FOR MEETING OF: JANUARY 9, 2018
CASE NO.: CU-SPR18-12

**SUBJECT: CONDITIONAL USE – SITE PLAN REVIEW
CASE 18-12; 1715 CAPITOL ST NE
AMANDA NOS. 18-120389-ZO, & 18-120390-RP**

Summary: A conditional use and site plan review to allow a religious assembly.

SITE PLAN
FLOOR PLAN

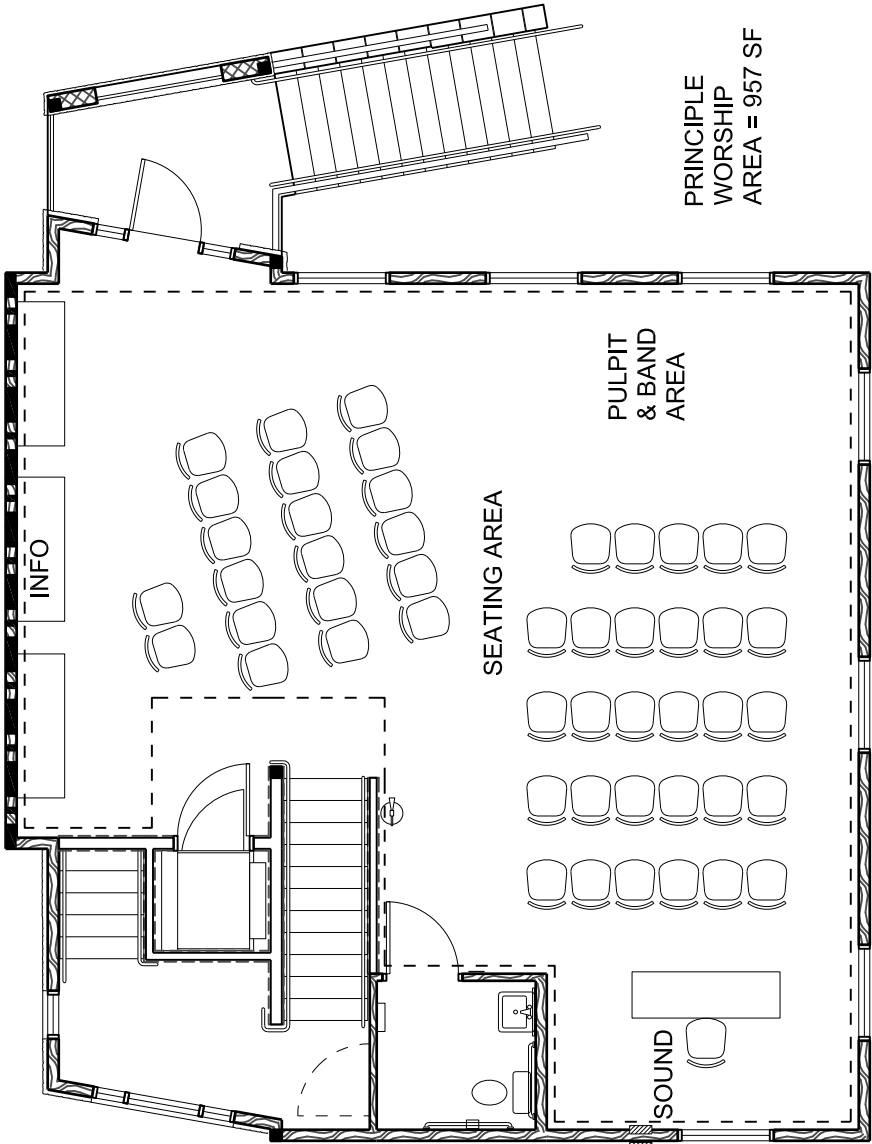
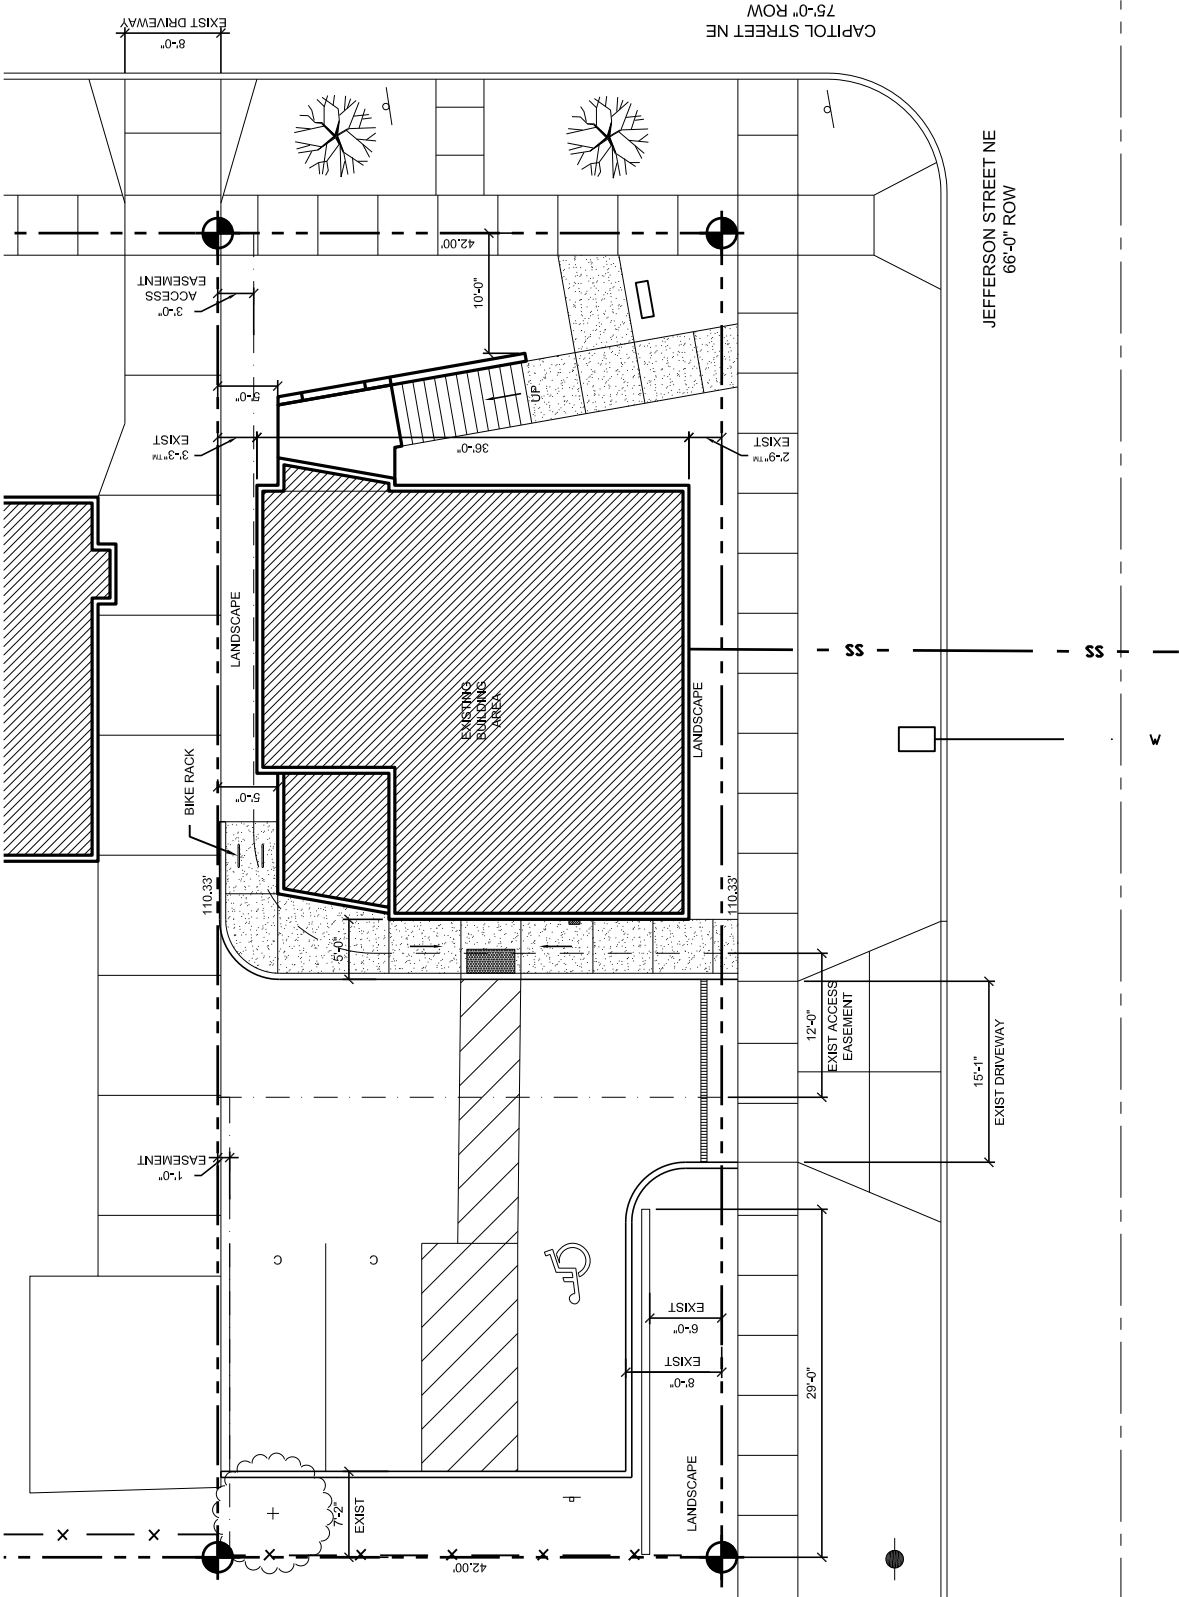
Condition 1: The proposed development shall be in substantial conformance with the approved site plan included as Attachment B.

Condition 3: The applicant shall install a sight-obscuring fence, wall, or hedge that complies with the vision clearance standards of SRC Chapter 805 and screening standards of SRC 807.015(e), and the minimum height of 6 feet shall be measured from the paved surface of the adjacent parking and vehicle use area.
